TO: Robert Palmer, Strategic Land Solutions, Inc.
FROM: Cynthia Thye, Planner I
DATE: April 3, 2026
SUBJECT: SP24-012: Parker Central Area F5 L2 B1 - McDonalds– Site Plan Amendment Review Comments 04

Description: Parker Central Area F5 L2 B1 - McDonalds

SHEET NO.: <h1 style="font-size: 2em;">EX1.0</h1>

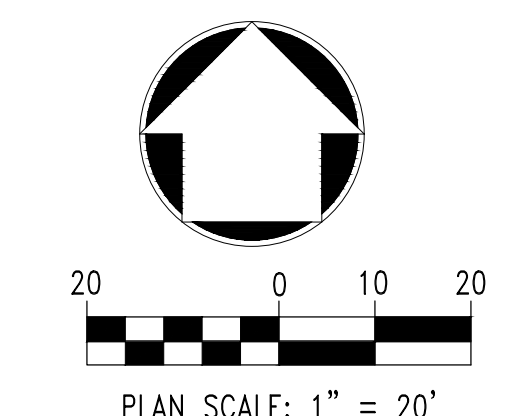
- 4. Explain this change with relines on building footprint. Also, sheet EX.1 shows the gross floor area of 5,758 square feet. Please explain why this shows existing at 6,088 square feet.

SCALE:	1" = 20'	MD RE:	BOWAN
DATE:	03/20/2026	MD P/CM:	MANN
DESIGNED BY:	RJP	FILE NAME:	CURRENT.DWG
DRAWN BY:	RJP	SLS NO. 14-001-47	
CHECKED BY:	RJP		
DRAWING TITLE:	SITE PLAN		
SHEET NO.:	C1.0

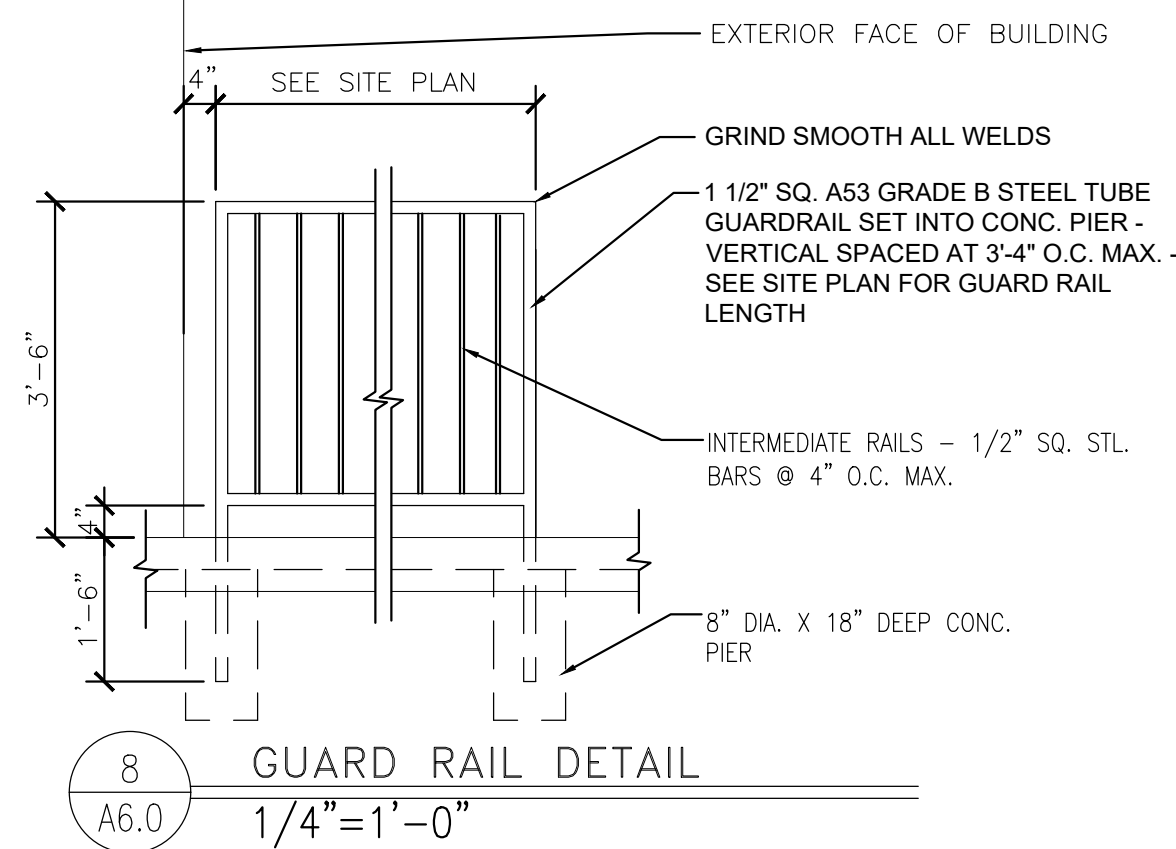
- 5. Revise location of trash enclosure and covered storage. Per DDS VIII.M.1.a., trash enclosure and storage cannot be located on Parker Rd, (a building front). Storage and trash enclosure need to be on side or rear of the building.

Per DDS VIII.M.1.a., trash enclosure and storage cannot be located on Parker Rd, which is a front. Storage and trash enclosure need to be on side or rear of the building.

SHEET NO:
LI1.0

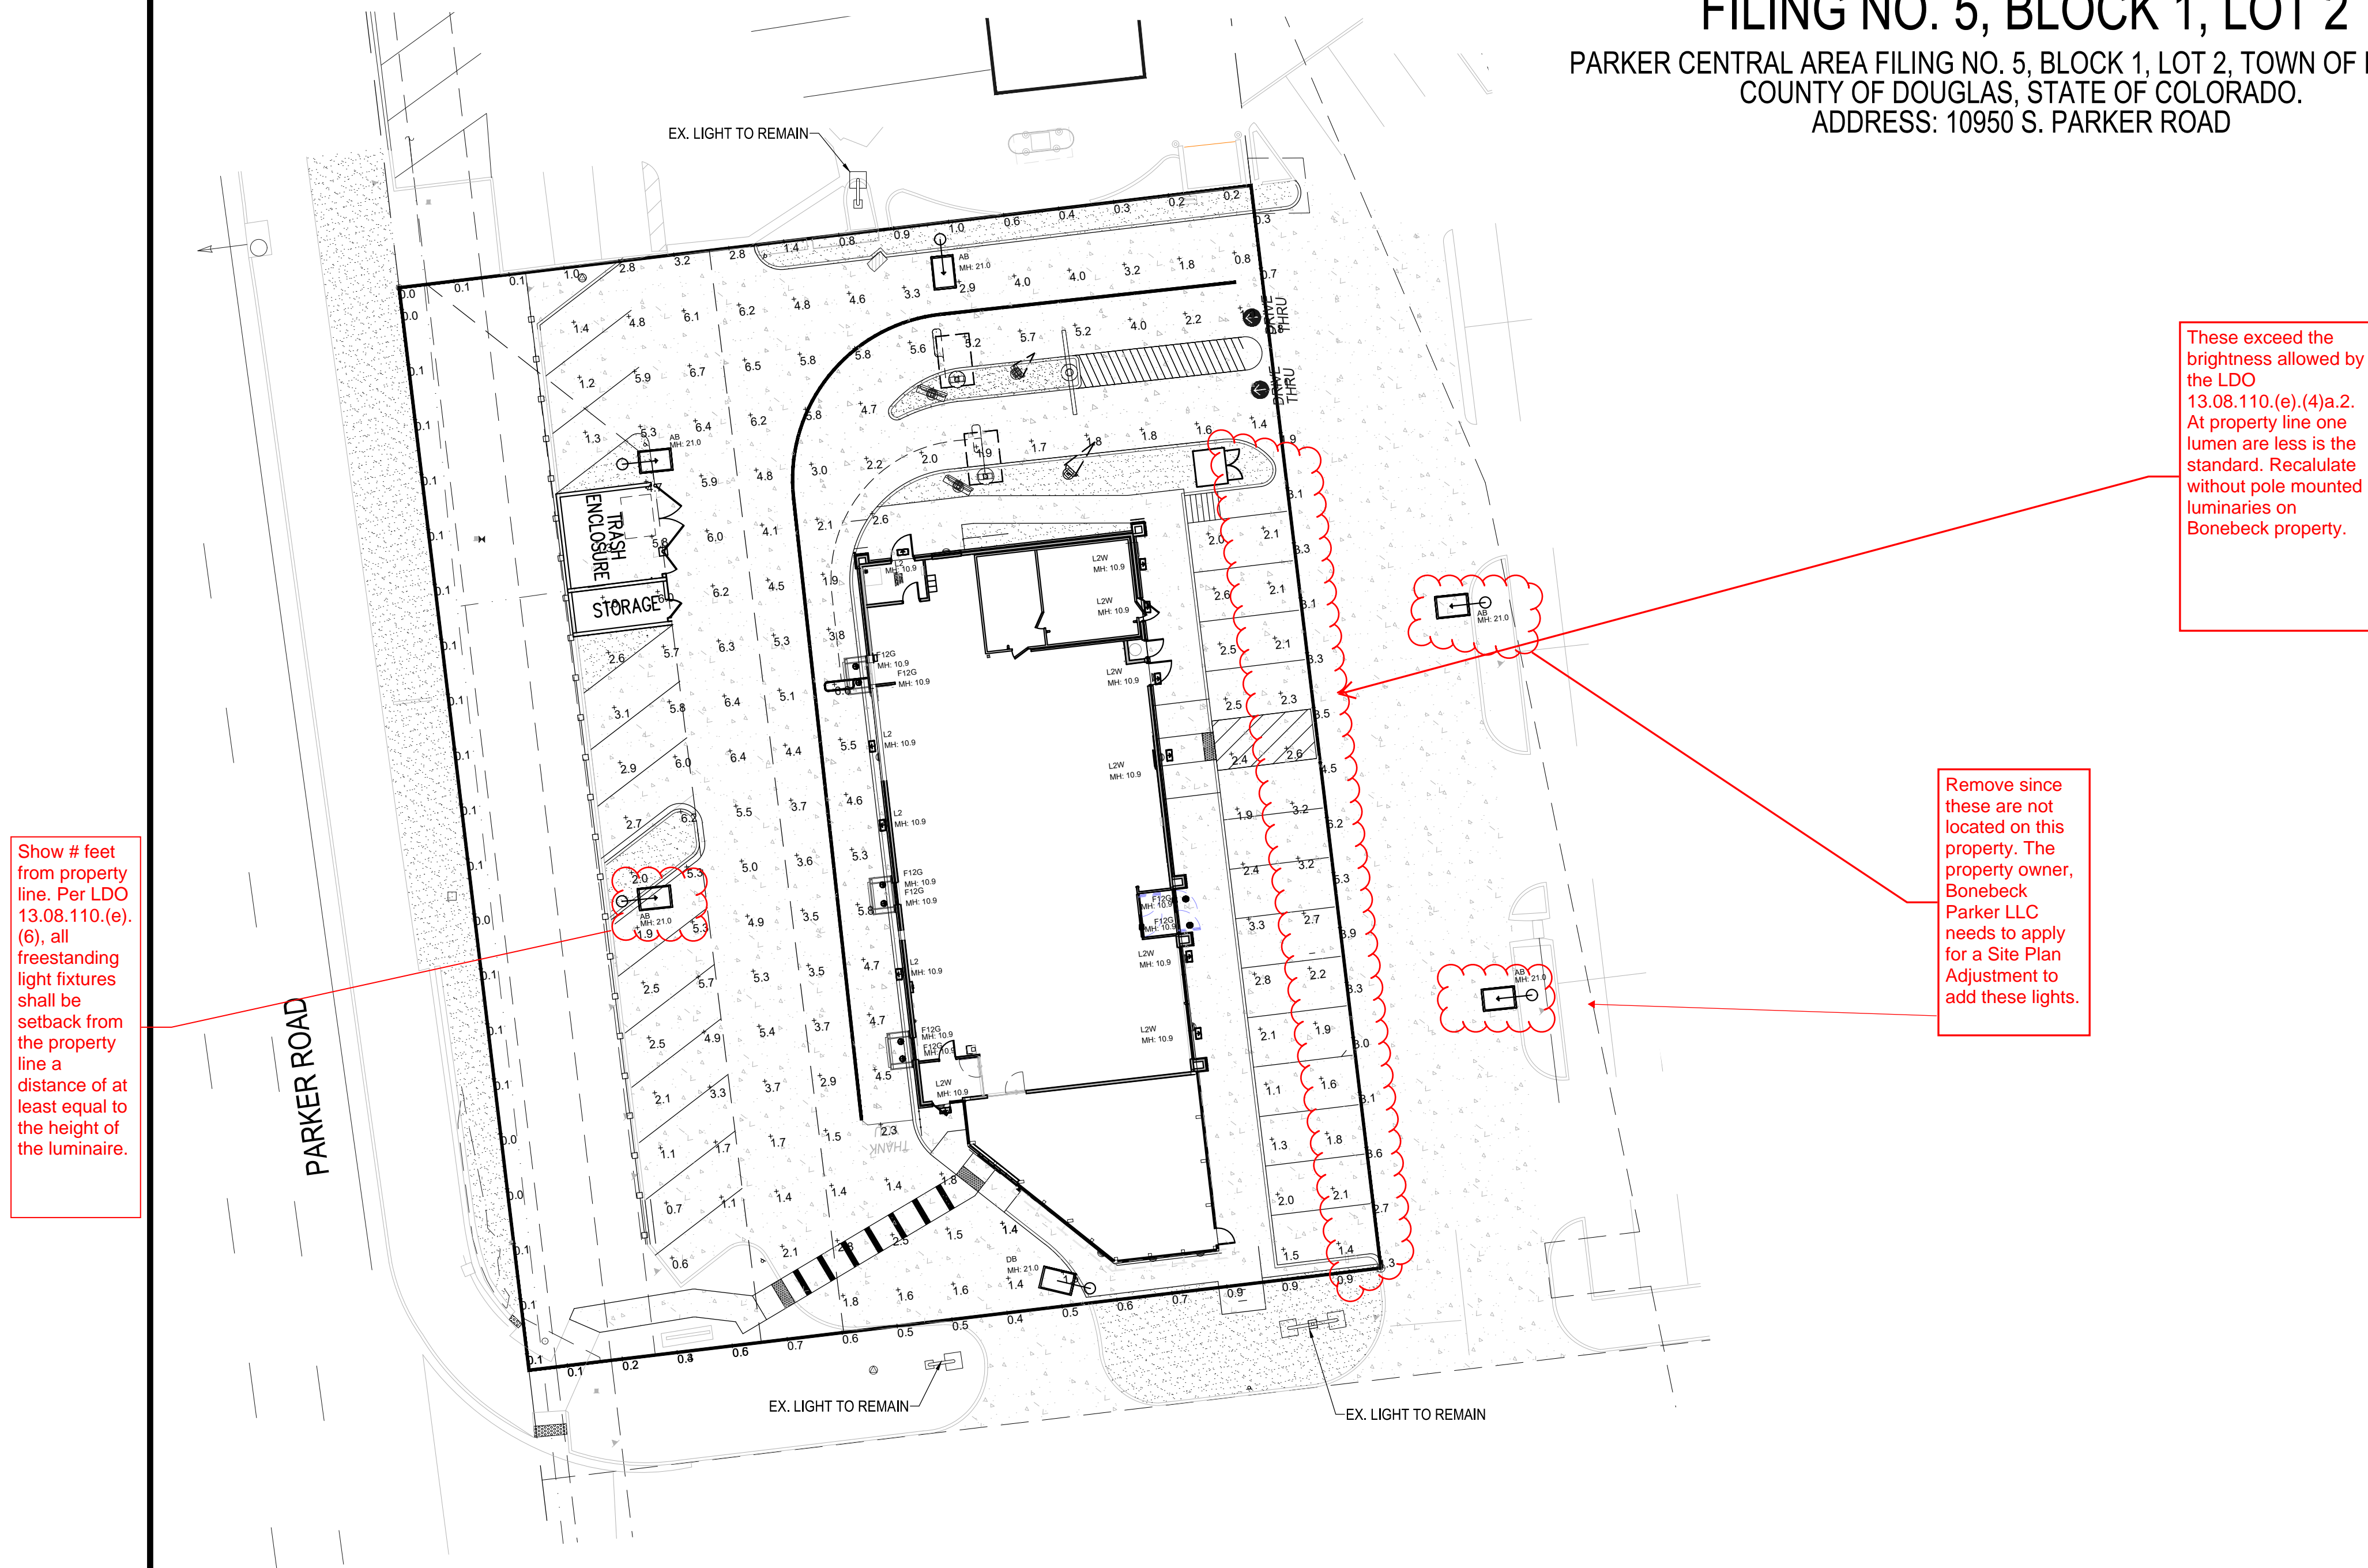
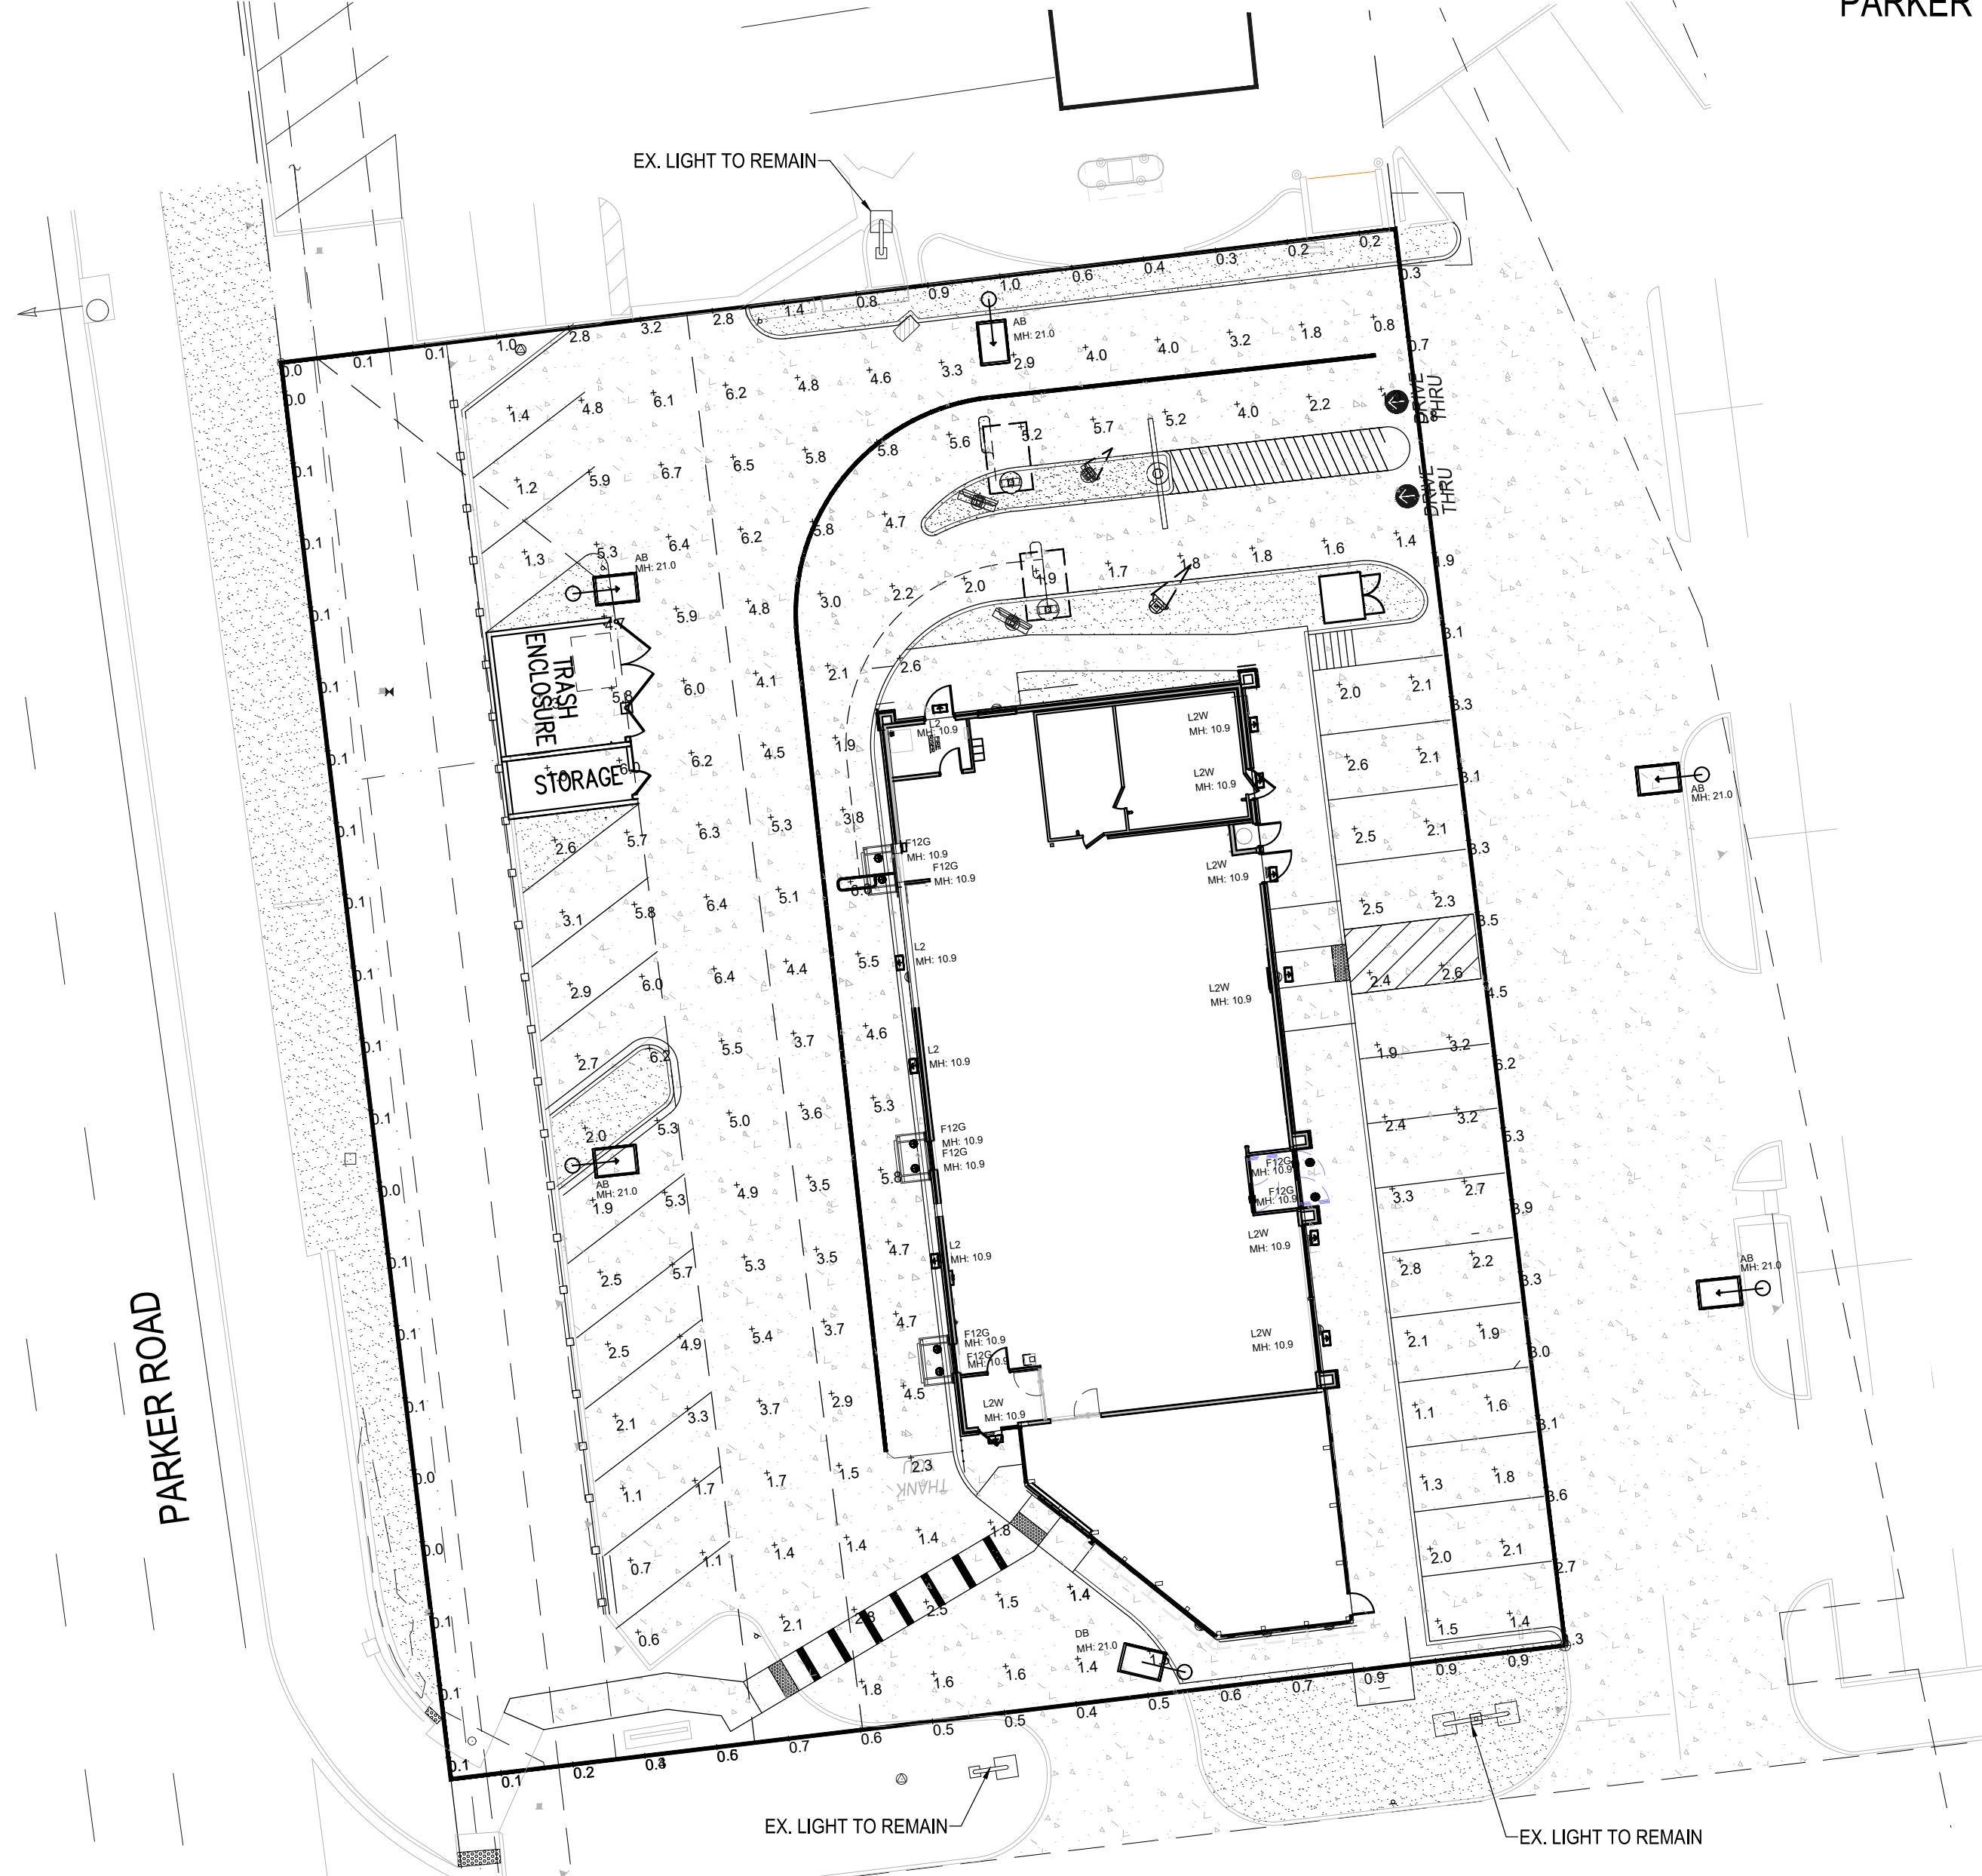
- 1. Regarding west light pole, show # feet from property line. Per LDO 13.08.110.(e).(6), all freestanding light fixtures shall be setback from the property line a distance of at least equal to the height of the luminaire.

- 2. Regarding east light poles, remove since these are not located on this property. The property owner, Bonebeck Parker LLC needs to apply for a Site Plan Adjustment to add these lights.

3. The lumens at the east property line exceed the brightness allowed by the LDO 13.08.110.(e).(4)a.2. At property line one lumen or less is the standard. Recalculate without pole mounted luminaries on Bonebeck property.

Show # feet from property line. Per LDO 13.08.110.(e). (6), all freestanding light fixtures shall be setback from the property line a distance of at least equal to the height of the luminaire.

Remove since these are not located on this property. The property owner, Bonebeck Parker LLC needs to apply for a Site Plan Adjustment to add these lights.
